RIFLE SPECIFICATION

PI-4

PROPOSED PRODUCT:		NBAR (NEW BOLT ACTION RIFLE) - WOOD STOCK VERSION PRELIMINARY SPEC. (ALSO SEE NBAR STAINLESS SYNTHETIC SPEC.)	
GRADE: "A"	CALIBERS: 222REM, 223REM, 243WIN, 6MM REM		
ORIGINAL DATE: 8/13/92	25-06REM, 270WIN, 280REM, 7MM-08REM, 308WIN		
REVISED: 8/28/92	30-06, 35 WHELEN, 7MMREM MAG, 300 WIN MAG, 300WBY MAG, 338WIN MAG		
METAL WORK		• BOLT: TiN or other surface treatments (COLORS) • LOCKING LUGS ONLY • INTERIOR OF RECEIVER ONLY • FIRE CONTROL KEY PARTS	
FINISH:	BLACK OXIDE: STD BLACK MATTE: _____ PARKERIZED: _____ OTHER: _____		
ADDITIONAL INFORMATION: _____			
RECEIVER:	SERIAL NUMBER FORMAT: NEW-TBD ROLL MARK (LEFT SIDE): NEW-TBD ROLL MARK (RIGHT SIDE): NEW-TBD ADDITIONAL INFORMATION: ONE PIECE BARREL / RECEIVER IS ACCEPTABLE SIMPLIFIED INTEGRAL SCOPE MOUNT "REMINGTON MOUNTING SYSTEM"	LASER-EMBELISHED / DEDICATED COSMETICS	
BARREL:	LENGTH: 21" LENGTH: 25" SIGHT HOLES: YES ROLL MARK: CURRENT	CALIBERS: 6MM, 243, 25-06, 308, 7MM-08 CALIBERS: ALL MAGS & L/A + 222, 223 SIGHTS: YES

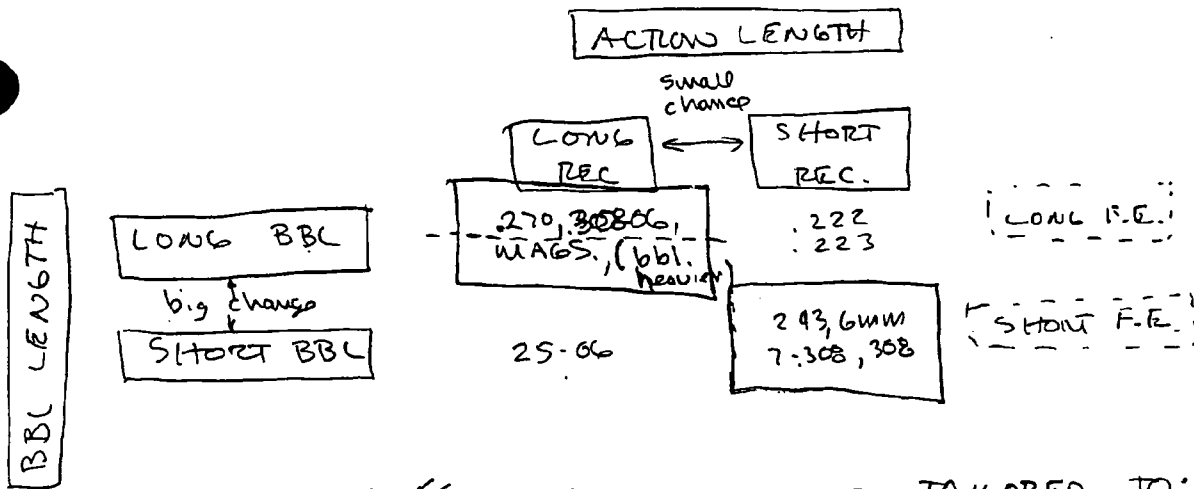
POSSIBLE: 4 STOCK VARIATIONS	ADDITIONAL INFORMATION: WILL LENGTH OF F.E. CHANGE TO MATCH BARREL LENGTH?		
STOCK & FORE-END			
MATERIAL:	SYNTHETIC: _____	MATERIAL: _____	
		COLOR: _____	
	WALNUT: YES BIRCH: _____ SYCAMORE: _____ OTHER: _____	GRADE: "A"	WHY THIS IF CONCEPT IS UPSIDE HIGH END?
CHECKERING:	NONE: _____ CUSTOM: _____ CUT: YES PATTERN: NEW - TBD OTHER: _____	8% OF LONG STOCK BLAMES AVE BEEN "B" GRADE WOOD ACCORDING TO G. HELMER.

POWDER METAL BE TiN COATED?
OVER/ INSTEAD OF CHROME PLATING

- 5 ~~4~~ STOCK VARIATIONS TAILORED TO:
- BARREL LENGTH (COSMETIC-PROPORTION)
 - ACTION LENGTH (INLETTING)
 - BBL COUNTOUR (+3/4 LB IN WAGS)

⇒ PUT 25-06 IN WITH "LONG BBL HUN" CALIBERS

GO FROM 4 TO 2

COMBINE BBL COUNTOUR ON LONG ACTION TO SEMI-MAGNUM.

ASSUME: F.E. LENGTH VARIES WITH BBL LENGTH TO PROVIDE AESTHETIC APPEAR.
